OFFICE OF THE SECRETARY
Minerals Management Service
Roswell District
NM OIL CONS. COMMISSION
Drawer DD
Artesia, NM 88210

SPECIAL APPROVAL STIPULATIONS

YATES PETROLEUM CORPORATION
3 Bosque Grande "SQ" Fed.
~~SELSEL~~ sec 8 T7S R26E
Chaves County, New Mexico
Lease No. NM-15294

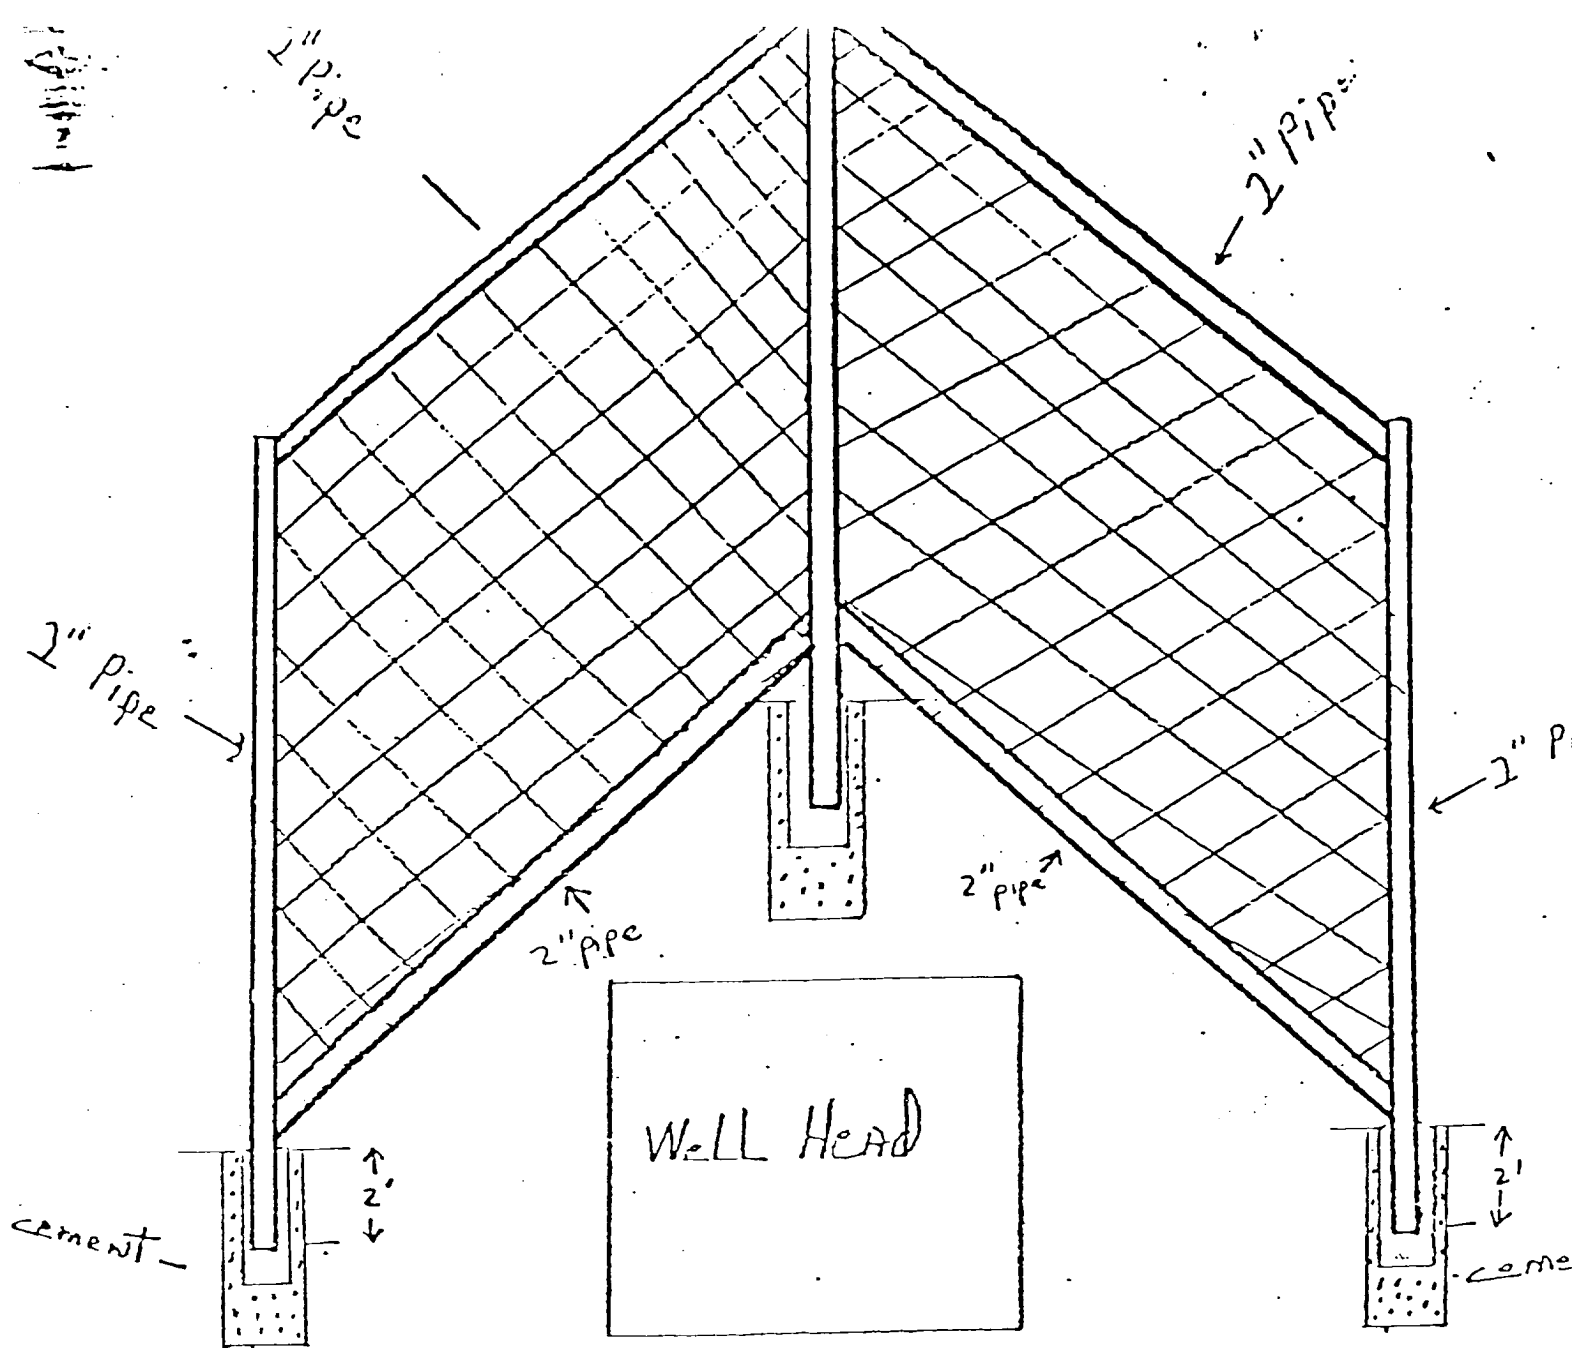
b. The well head will be buried below ground in a concrete cellar with a grate over it.
or
c. Three steel posts will be set in concrete. Horizontal steel cross bars will connect the the posts. Heavy guage chain link will be welded or bolted to the post and cross bars. (See attached diagram) The V must point upstream or in the direction specified.

☒ (13) The separator will be protected and placed according to the following:

☒ b. Well is located in the upper floodplain so the separator will be placed behind the wellhead barrier.

Height-- 6 feet or as tall as Well head

Width-- 6 foot Panels with chain Link Fence wire
 3 post holes with cleaves to insert pipe set in place by
 cement.
